SUNDRY NOTICES AND REPORTS ON WELLS

Mobil Oil Corporation

(other) Change Location

LINDRITH "B" UNIT #2
 1739' FSL, 861' FWL
 SEC. 28, T-24-N, R-3-W
 RIO ARriba COUNTY
 NEW MEXICO

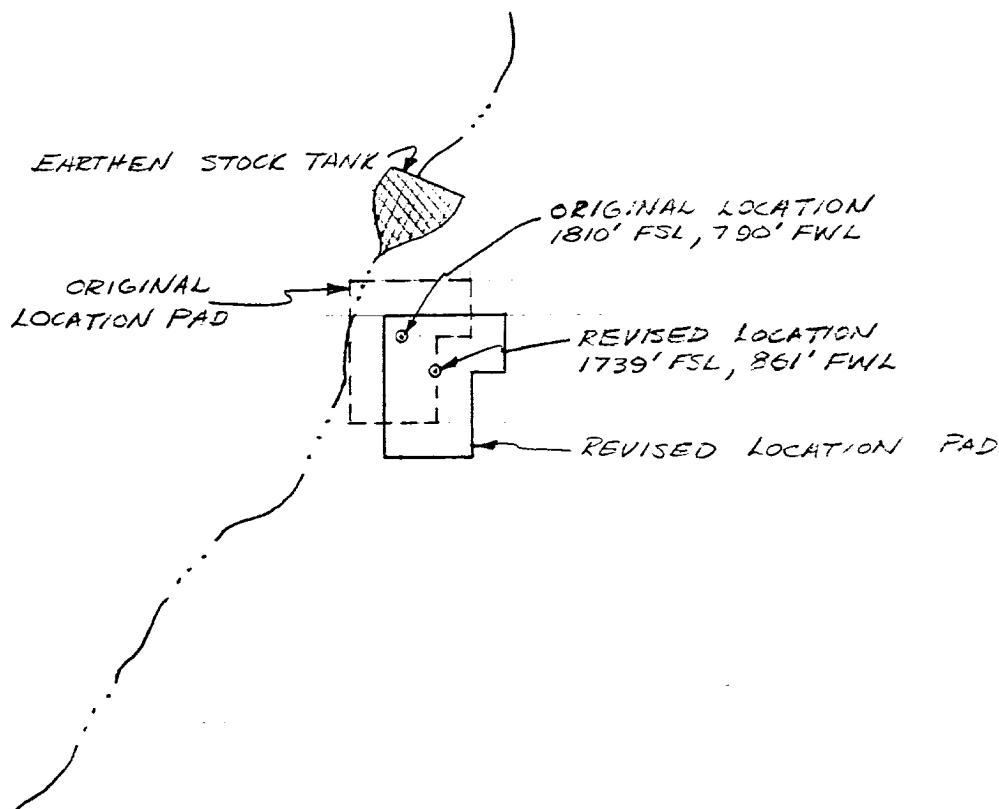
REASONS FOR MOVING LOCATION 100' SOUTHEAST:

- TO CLEAR LOCATION PAD OF NATURAL DRAINAGE DITCH.
- TO GET RESERVE PIT AREA FARTHER FROM EARTHEN STOCK TANK.

SUBJECT NEW LOCATION OF

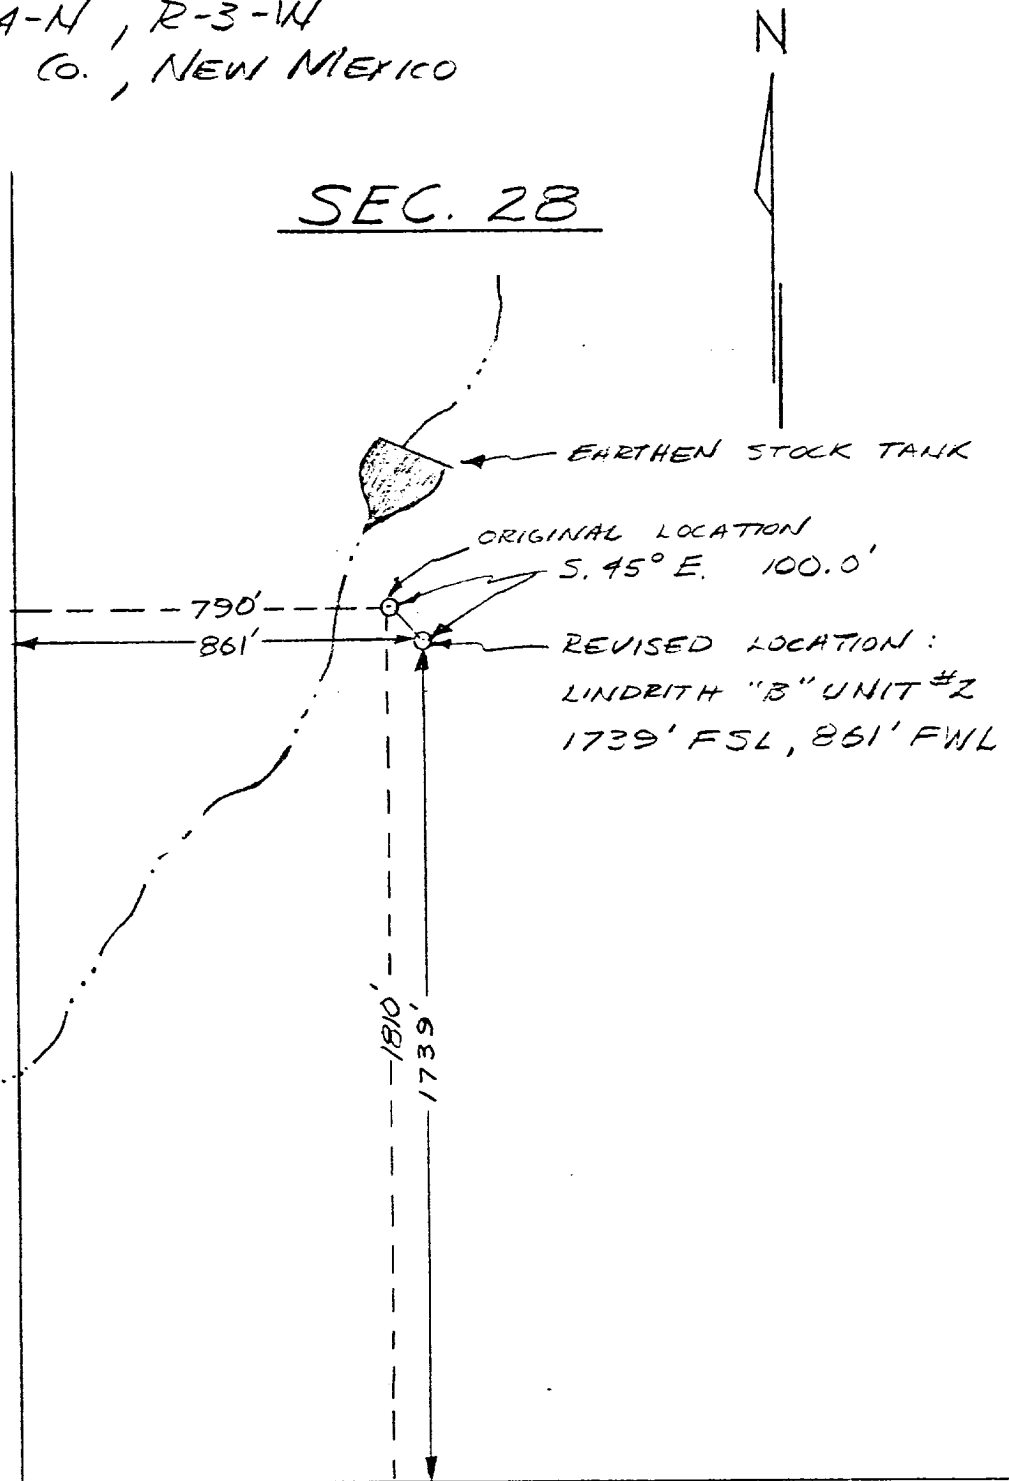
Location moved to clear location pad of a natural drainage draw and to get reserve pit farther away from an earthen stock tank.
